| Model: Schmidt1                    |   | Date: 15-Feb-99   | No.: 1   |
| Subject: Service Manual Correction |   | Prepared by: K. Misugi  |  |

This RTB is to inform of corrections to the Schmidt1 service manual.

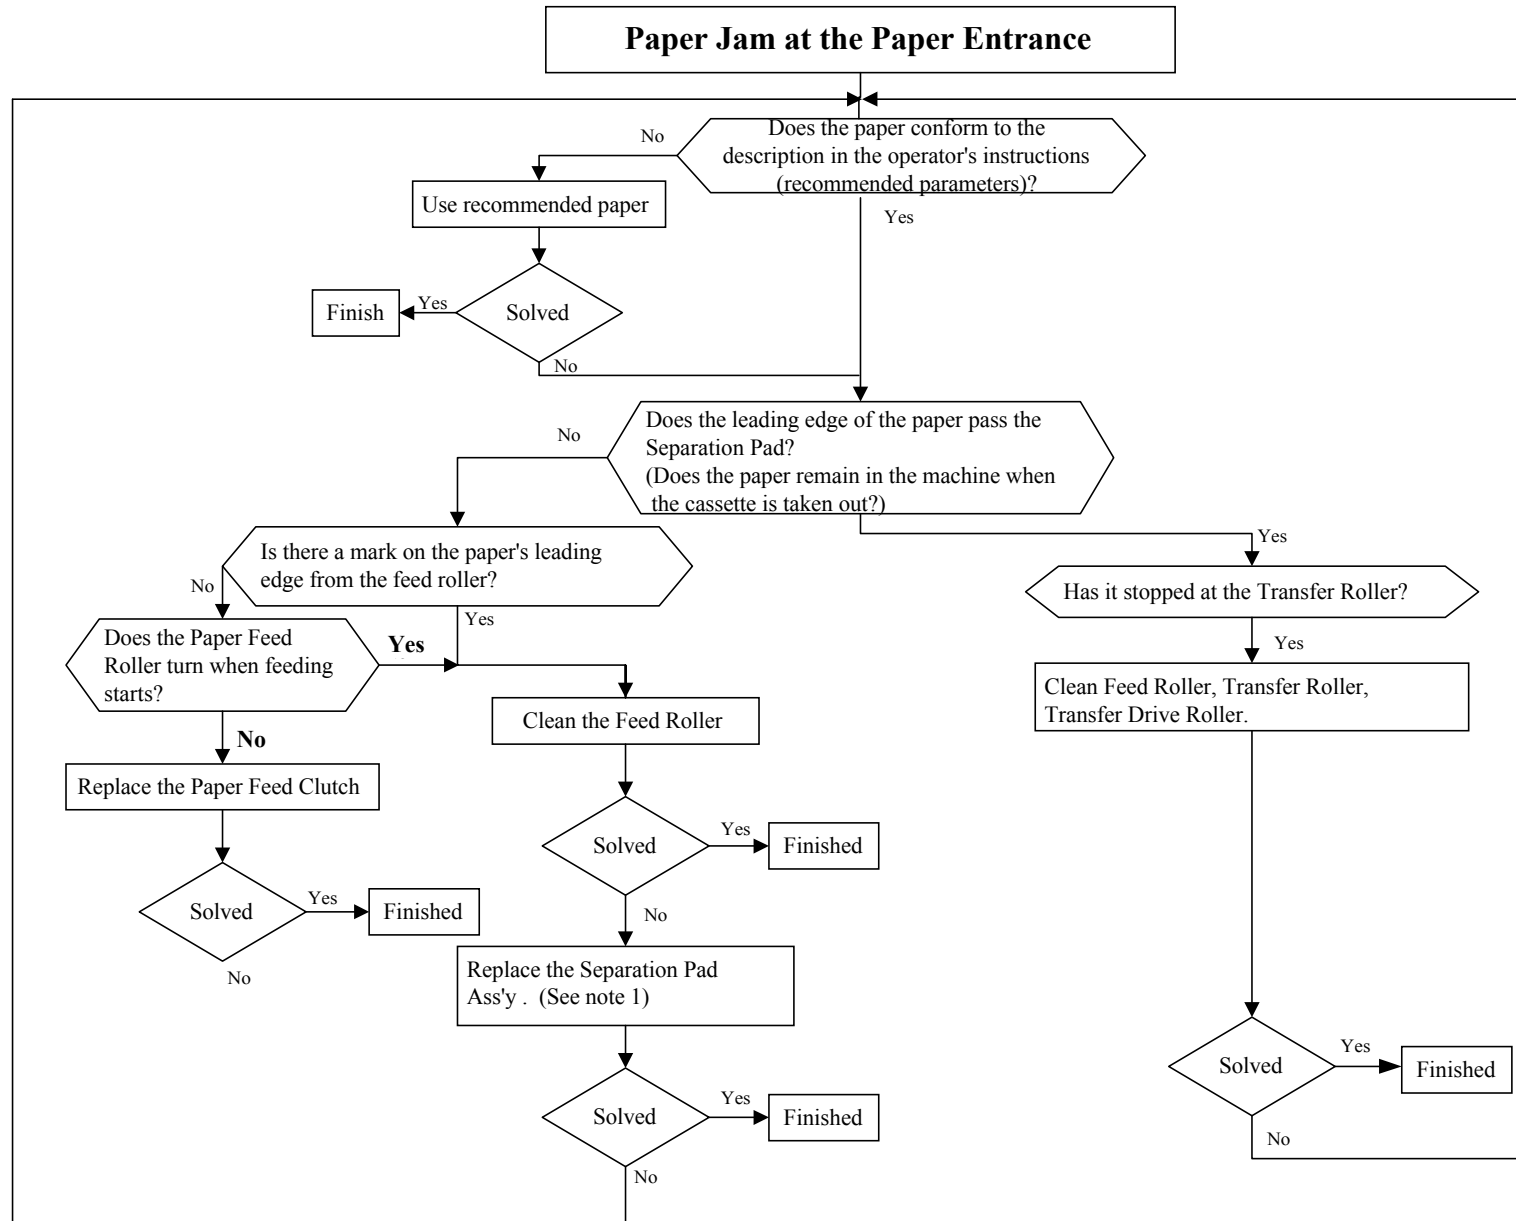
- 1) The Separation Pad Assembly (H5353006) for Model S-4 can also be used in the S-1/2/3. This assembly works better for paper feed/separation.

Please try using this assembly if the customer frequently reports paper non-feeds. However, because the noise level may be increased, please do not use the part for customers who may be sensitive to this.

Installing the new paper feed clutch

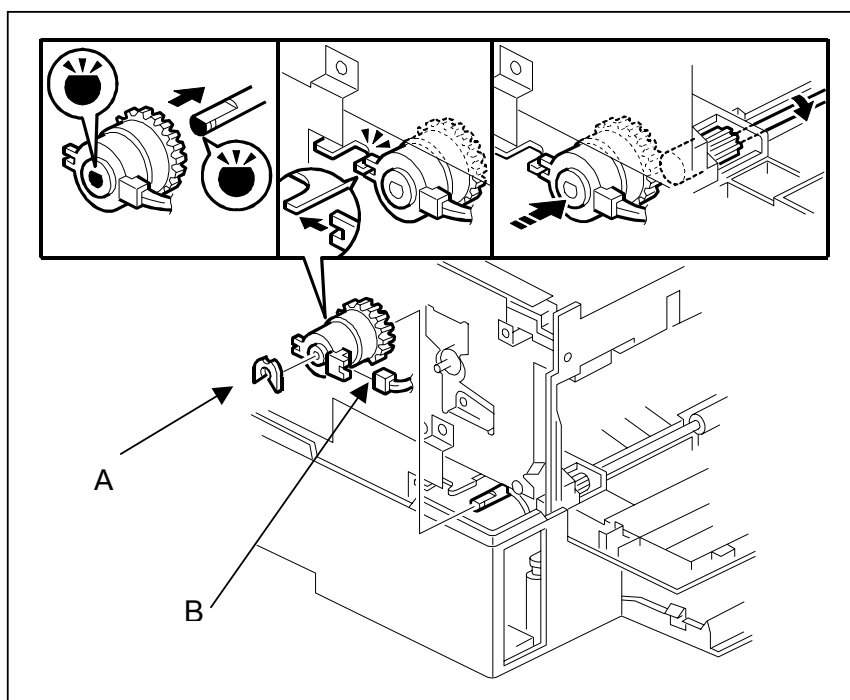
4. Surface of the paper feed roller:  
Clean the roller if the surface shows dust or other particles.
5. Replace the paper feed clutch from H5455077 → H5465070:  
For easier replacement, see the procedure below.
6. Replace the paper separation pad.  
H5453155 → H5463112.

1. Attach the paper feed clutch connector.
2. Mount the clutch onto the D-shaped paper feed roller shaft.
3. Attach the clutch stopper onto the side plate as shown.
4. Adjust the shaft in the clutch hole so that the paper feed rollers rotate.
5. Secure the clutch in place by attaching the plastic clip.
6. Reattach the FCU board, FCU cover and top cover.

**SOLUTION**

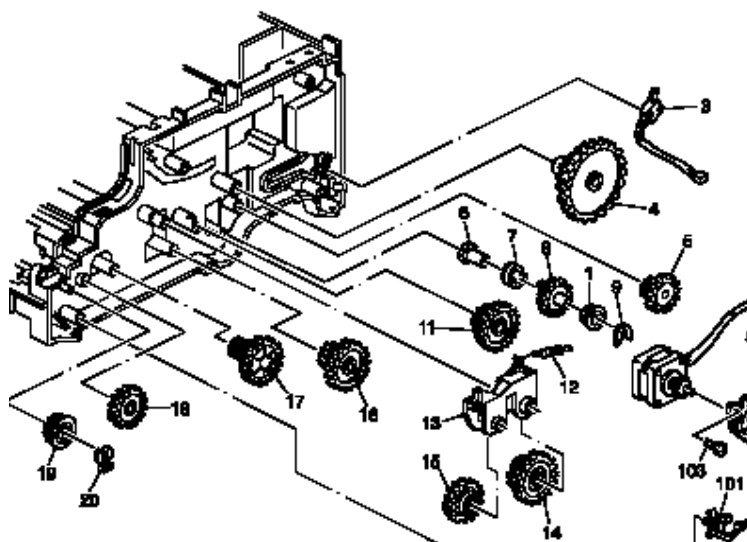
1. Increase the main motor drive power by increasing the motor current from 0.75A to 1.0A (overwriting SRAM data):

- Change RAM address 800715 from 40h (default) → 00h.
